RECOMMENDATION REPORT

H: Via Dora Drive

APPLICANT: LJA Engineering, Inc.

LJA Engineering, Inc. – on behalf of Castlerock Communities, L.P. – is requesting the deletion of the proposed Major Thoroughfare Via Dora Drive from Golf Club Drive to Red Summit Drive in the Major Thoroughfare and Freeway Plan (MTFP).

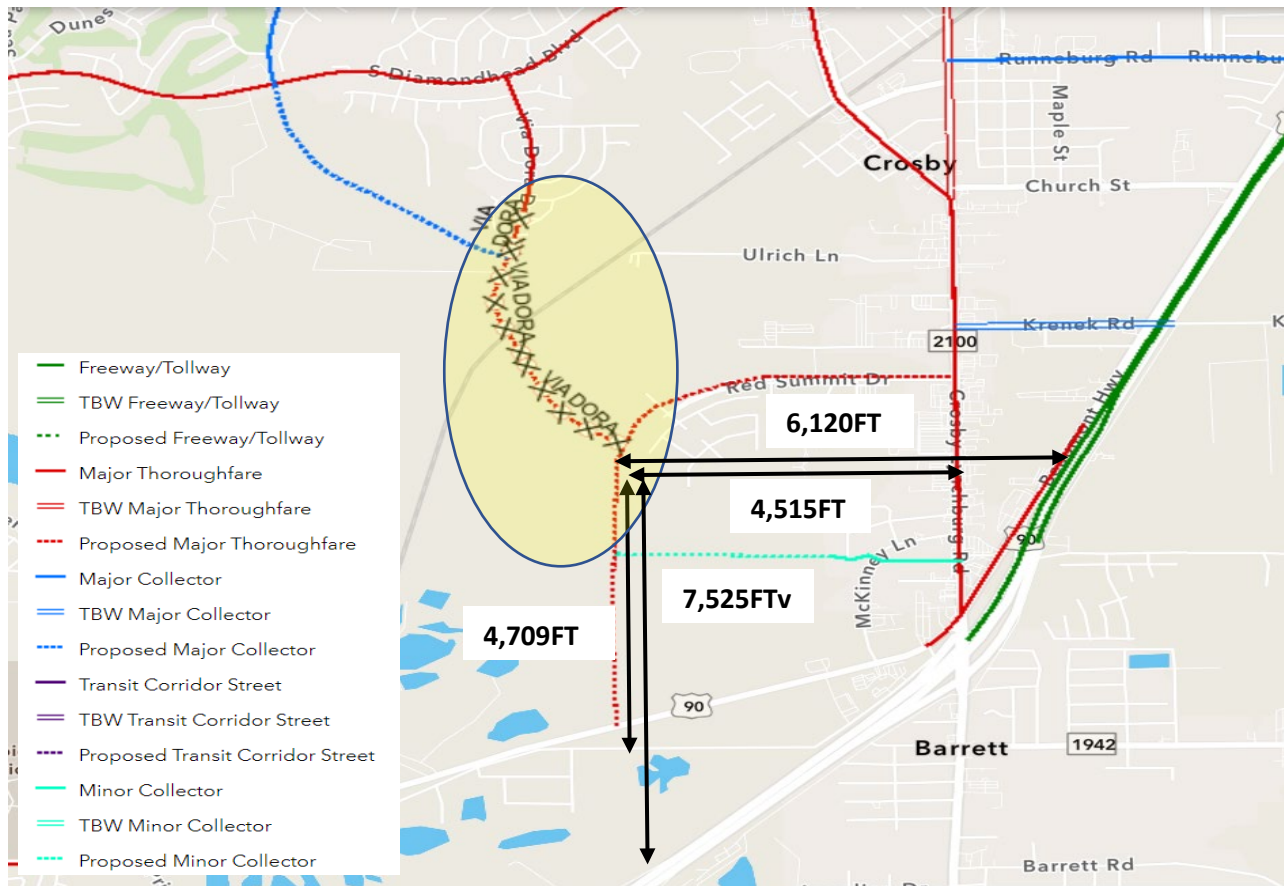
Land use surrounding the proposed deletion of Via Dora Drive is mixed. The alignment traverses agriculture production with industrial and commercial uses primarily situated to the east. To the west and south of the alignment, land use is predominately undeveloped commercial. A summary of platting activity that has occurred within the study area is shown below. There have been 6 plats filed in the area of the proposed amendment since 2014, with over half of them filed since 2021. The plats are primarily distributed east of the proposed amendment area.
